Subject: NRC Comments on NEI 22-05, Rev. A
Sent Date: 4/17/2023 3:14:19 PM
Received Date: 4/17/2023 3:14:00 PM
From: Michael Orenak

Technology Inclusive Risk Informed Change Evaluation (TIRICE)

Guidance for the Evaluation of Changes to Facilities
Utilizing NEI 18-04 and NEI 21-07

Figure 2. Overall Plant Performance Change in Example 1

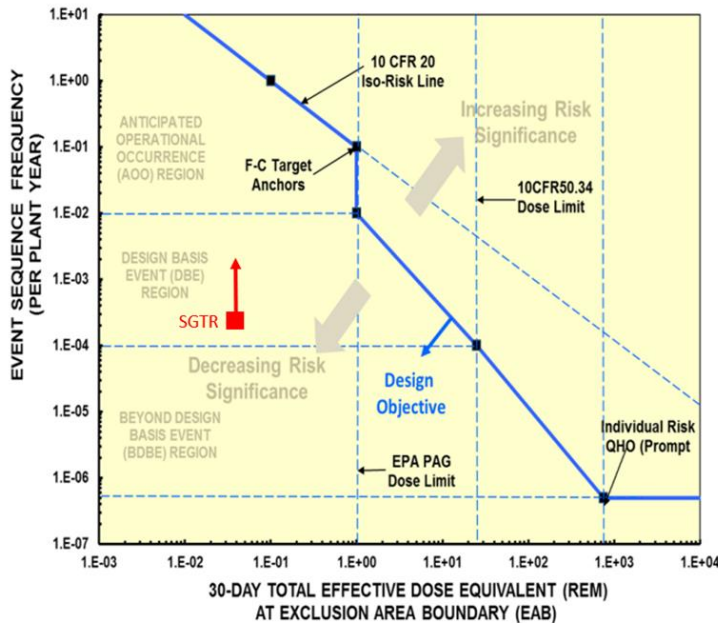
Commented [A17]: For LBEs that are already risk-significant, it would appear that Criterion (b) wouldn't apply, only Criterion (a). Is a change that moves from the far left side of the risk-significant region to the far right of the same region (i.e., close to the F-C target line) considered as not needing NRC approval? Has this type of change been considered when developing this guidance?

Figure 5. Identification of a New Risk-Significant Flooding Sequence in Example 2

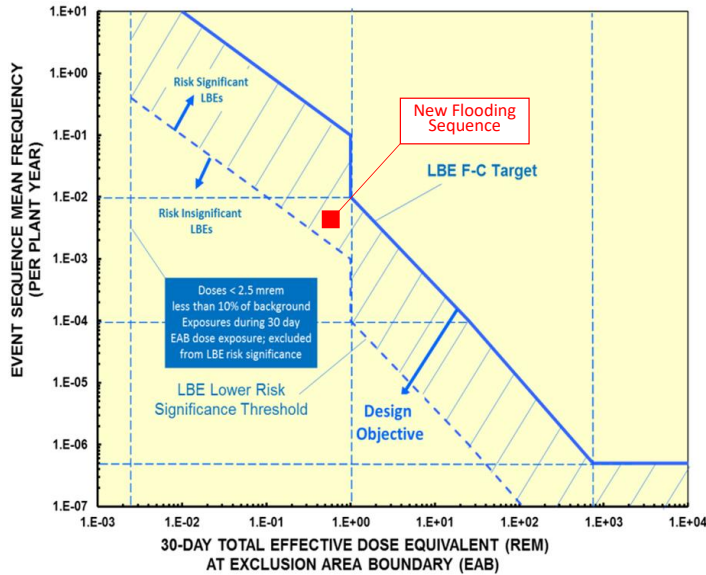
Commented [A20]: Could a new DBA be related to a new non-risk significant DBE? When looking at Task 6 in NEI 18-04, the deterministic DBAs are taken from all DBEs (not just the risk-significant ones determined in Task 7c). A new DBA through this pathway would not seem to be covered by criterion (d) or any other criterion herein.

Commented [A21R20]: In addition, could there be a scenario where a DBA was selected to address several DBEs (event families) and later it is determined to introduce a new DBA - not on the introduction of a new DBE but to address some operational or analysis issue - related to the performance of specific SR SSCs?
